Customer No.: 31561  
Application No.: 10/064,882  
Docket NO.: 7857-US-PA

**REMARKS****Present Status of the Application**

**AMENDMENTS TO DRAWING FIGURES:**

FIG. 1

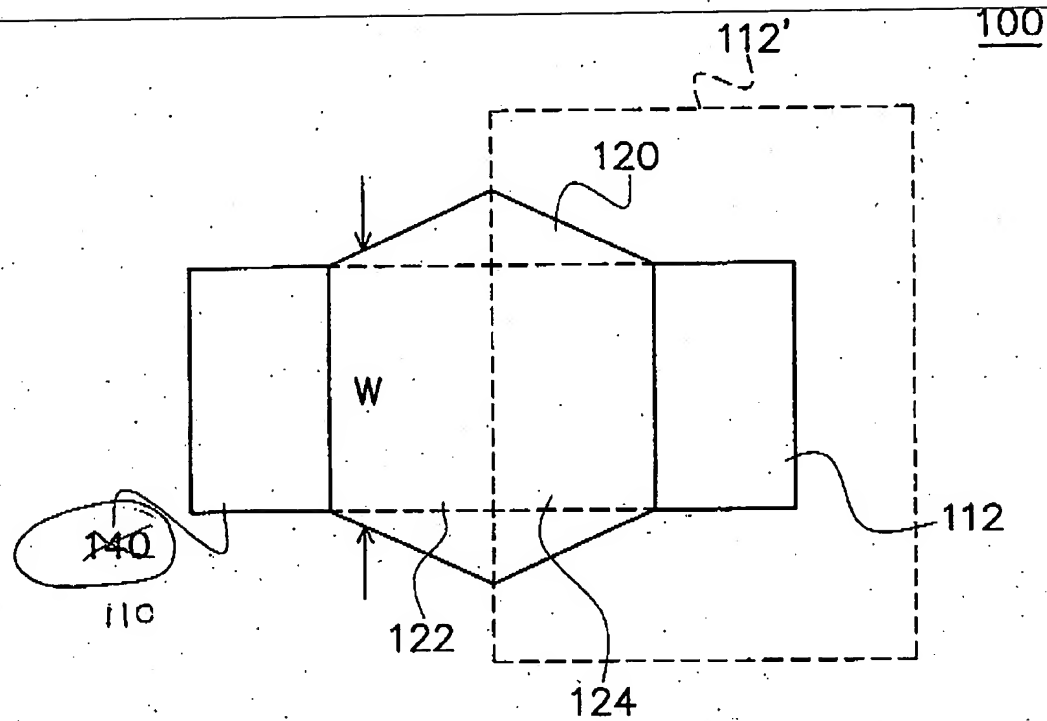
*1. The Office Action objected to the drawings for failing to comply with 37 CFR 1.84 because reference character 140 has been used to designate both a drain region and a channel region. The drawing is further objected to for the reference "112" mentioned in the description is not included in the drawings.*

*2. The Office Action objected to the drawings for failing to comply with 37 CFR 1.84(p)(5) because they include the following reference sign(s) not mentioned in the description: 112' in Fig. 1.*

In response thereto, Applicants have proposed to amend the drawings as a separate accompanying pages. After entry of the proposed amendments to drawings, it is believed that the above objections can be overcome. Reconsideration is respectfully requested.

Further, with regard to reference "112", the Examiner's attention is kindly directed to Figs. 1-3, where the reference "112" is shown to represent "a source region". Accordingly the above objection is moot. Reconsideration is respectfully requested.

Please Amend the Drawing Figure 1 as shown in red ink and as presented in the  
replacement figure 1.
